**CITY OF TEMPE
DEVELOPMENT REVIEW COMMISSION**

Meeting Date: 08/09/2016
Agenda Item: 4

ACTION: Request for a Development Plan Review for modifications to building elevations for 15 single family attached townhomes for THE BLOCK ON ROOSEVELT, located at 233 South Roosevelt Street. The applicant is Intent Development Advisors.

SOUTH ELEVATION UNITS 8-14
SCALE: 1/8" = 1'-0"

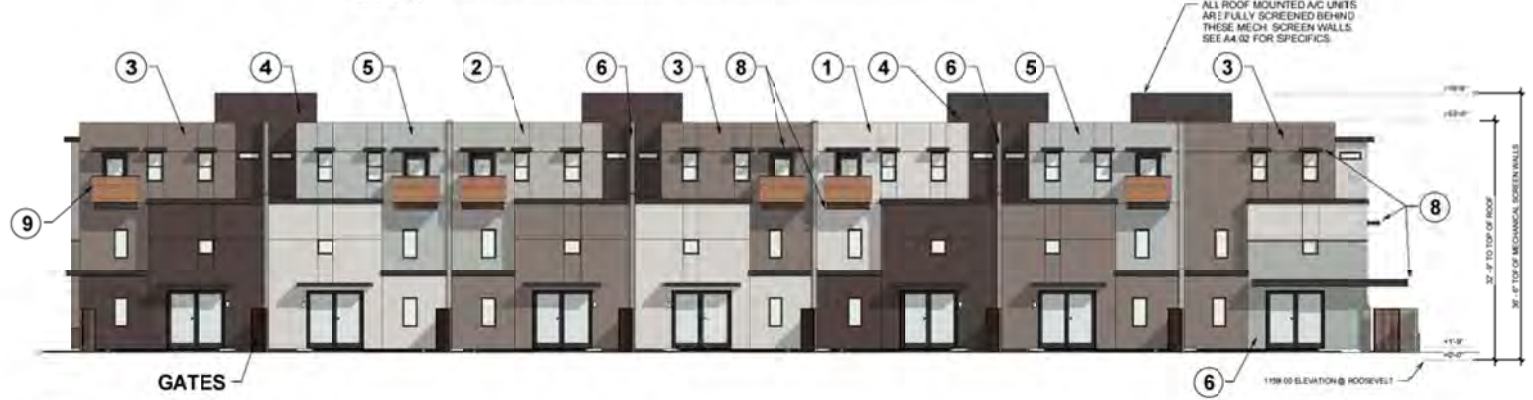
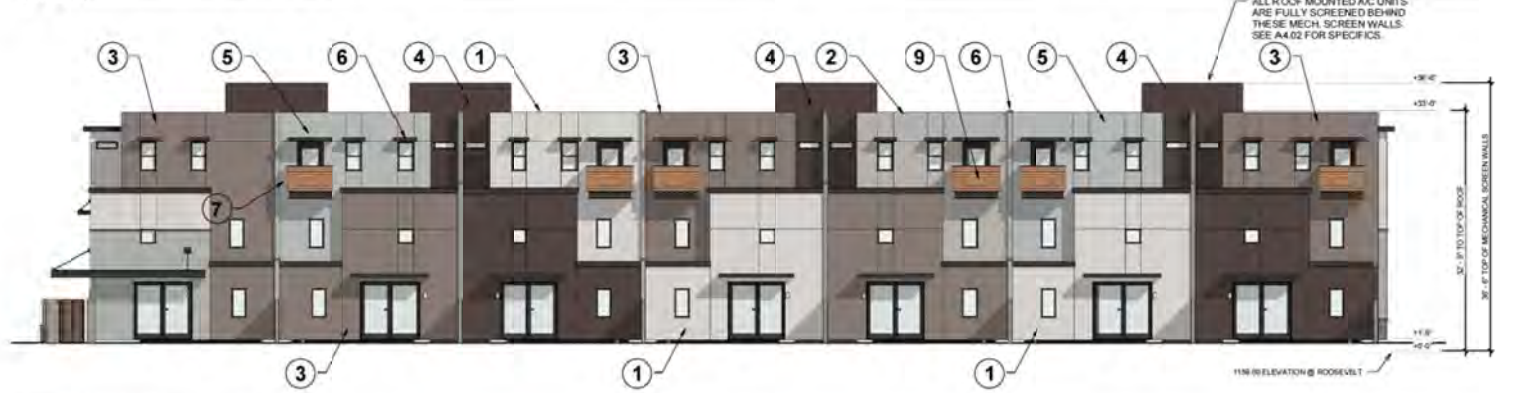
- With regard to the south elevations, these were substantially improved from the original, however staff requested shade over all doors, this means the projection from the upper pop-out needs to be deep enough to provide shelter, and those that do not have architectural pop-outs should have a canopy covering the back patio.

- Shade canopies were added over the exposed doors and architectural projections were extended to 36”.
- The garage doors were changed back to match the original proposed design with frosted glass panels.

D.R. EAST & WEST ELEVATIONS UNITS 1 AND 14
SCALE: 1/8" = 1'-0"

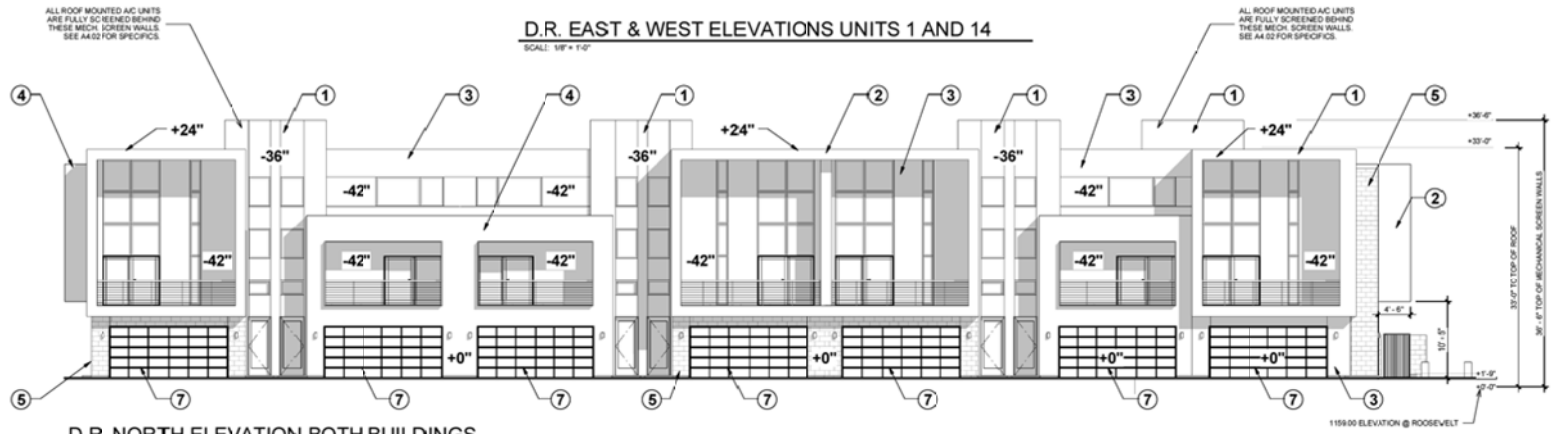
- With regard to the east/west elevations, staff wanted the front patios to be substantially protected with a useable porch area, with a depth of overhang of 5-6', it appeared to only be 30", but were not dimensioned.

- The applicant changed the material board to match the renderings.
- The material was verified and board updated with the correct sample.
- The elevations were updated to clarify the recesses and projections, and the architectural wrap over the street facing units was expanded to 54” to allow greater front patio depth.
